November 3, 2021

Re: New Elk Mine
Permit C-1981-012
MR-128

Below are responses for the MR-128 Adequacy Review:

DESIGNED BY: * DRAWN BY: NM	DATE: 10/27/2021 SCALE: AS SHOWN
	MR 128 Map 3

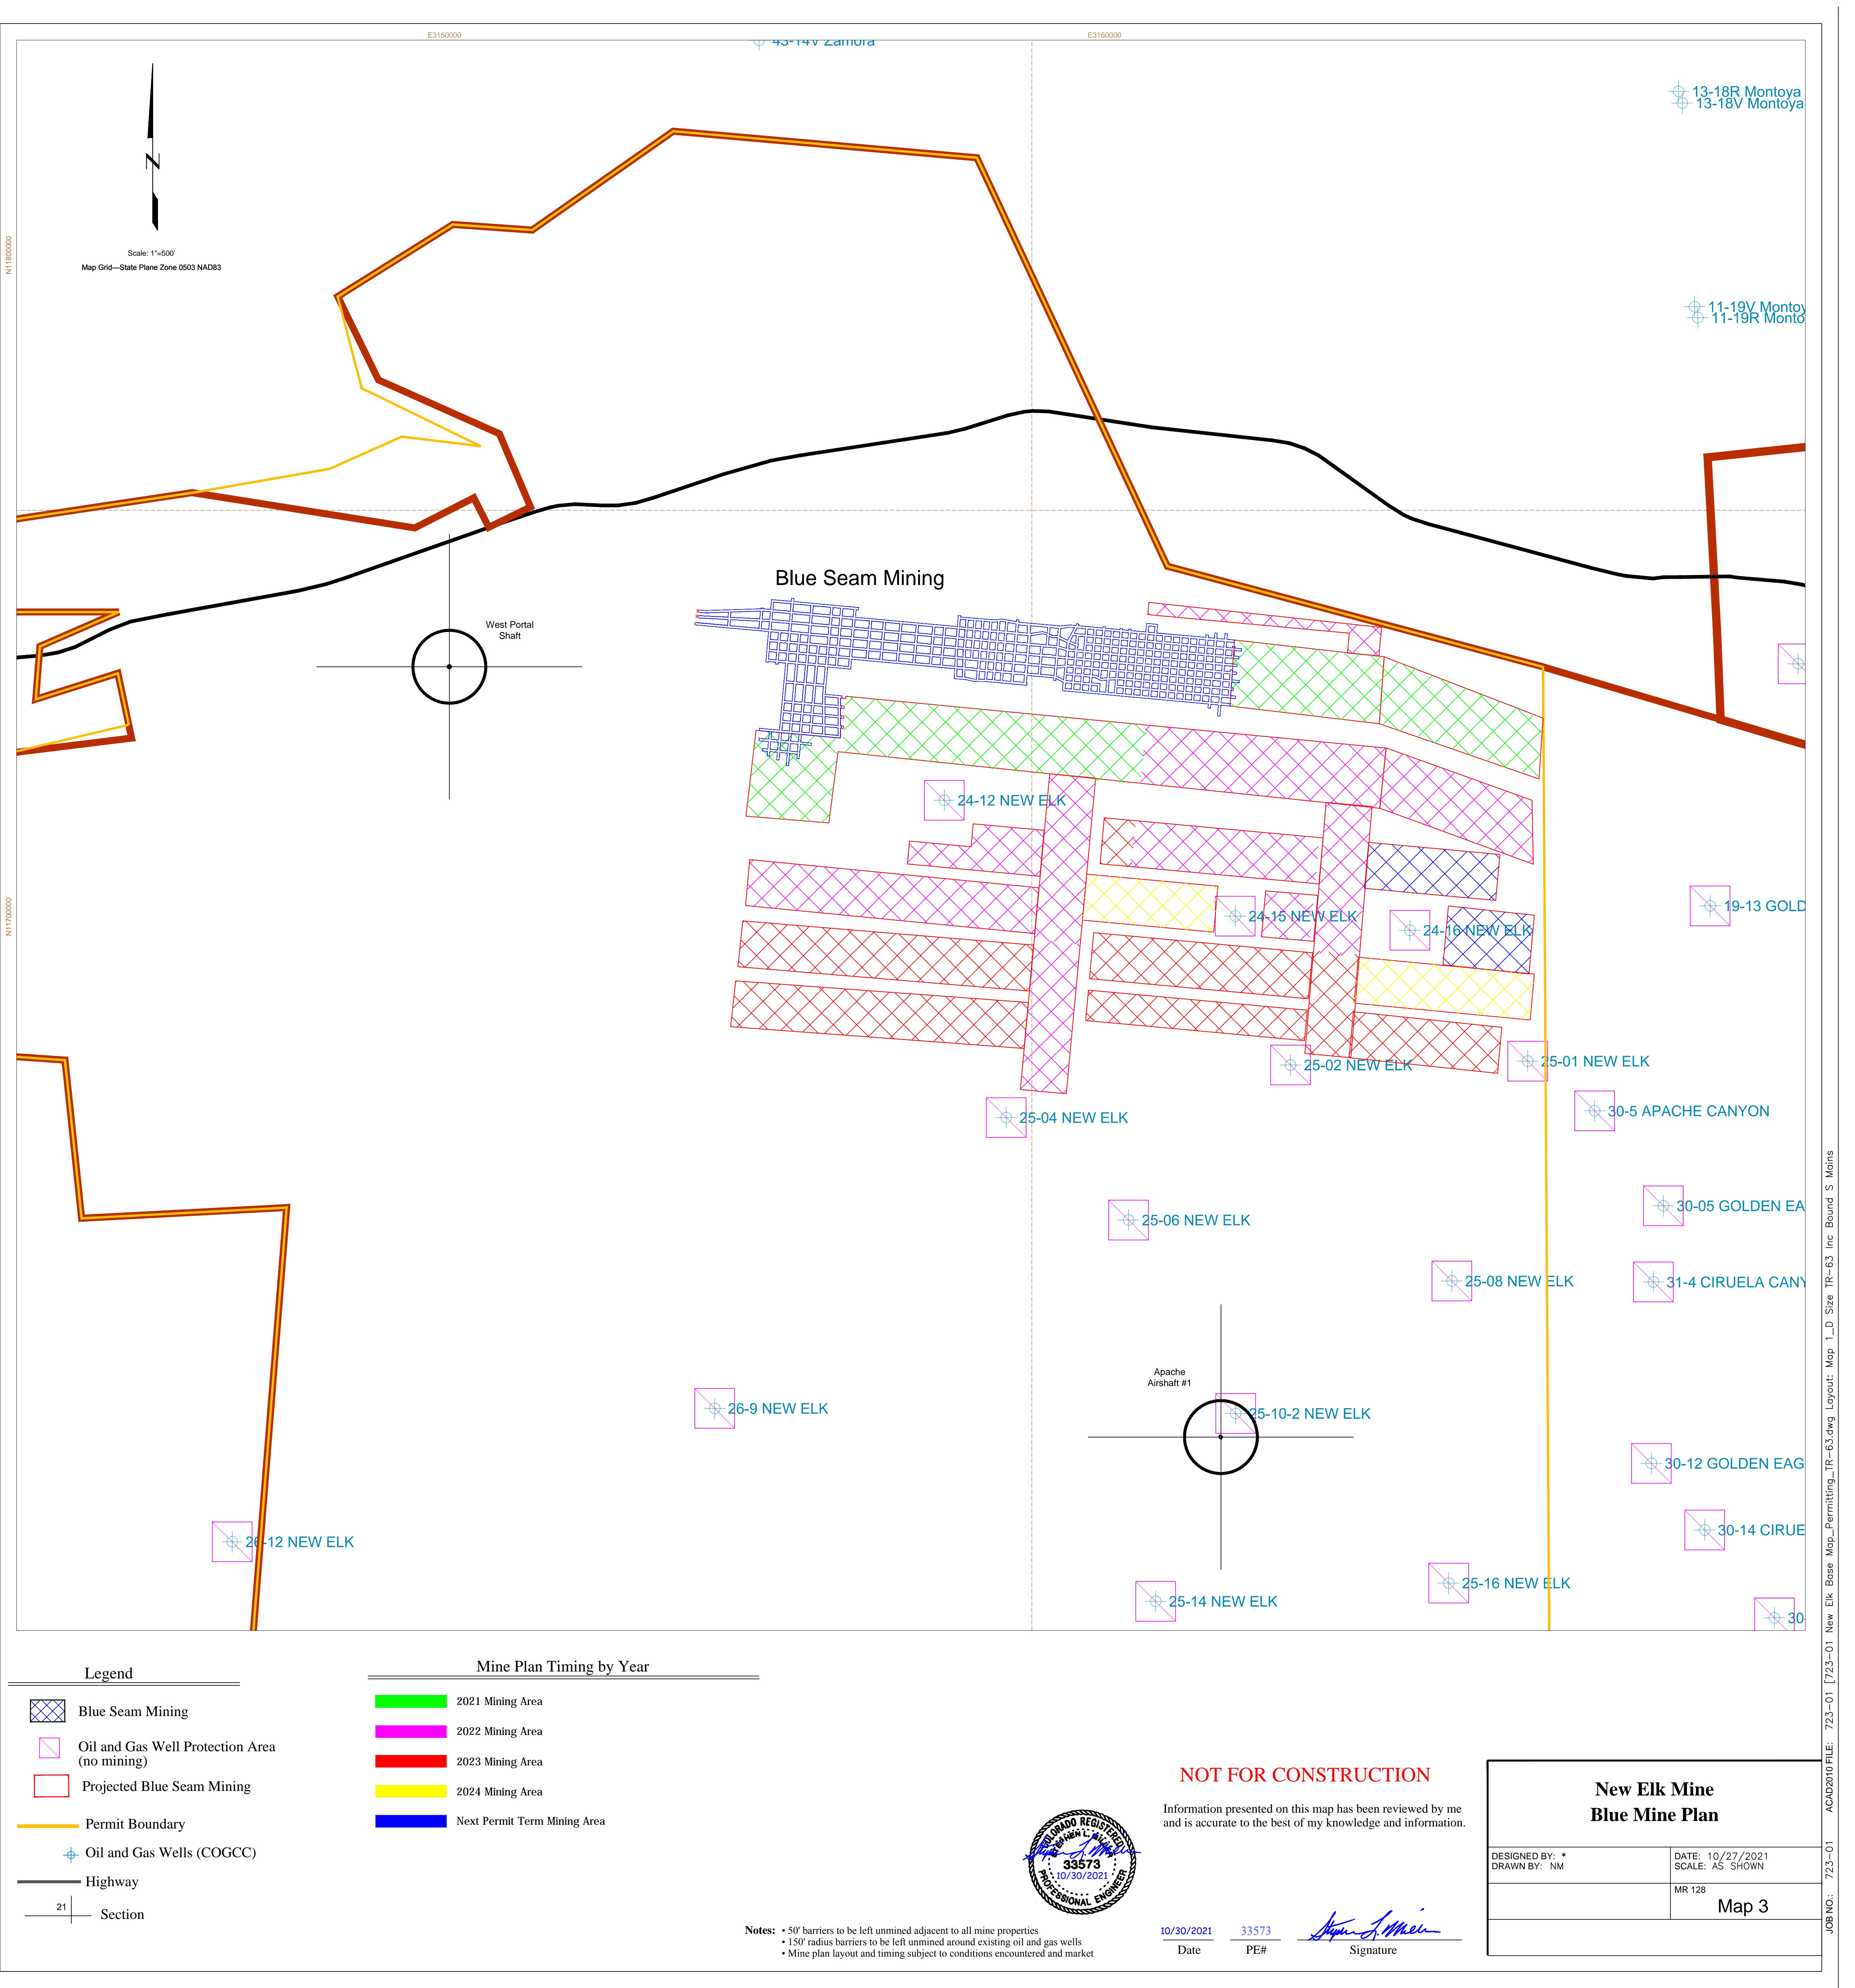
Rule 2.05.2 – Operations Plan – Estimated Area for Life of Operation:

1. Map 3 has been revised to show the currently approved permit boundary.
2. Map 3 has been revised to show the mine plan for the current five-year permit term.
3. Map 3 has been revised to show no mining outside the approved permit boundary.
4. Map 3 has been certified by Steve Miller, a professional engineer in the state of Colorado.
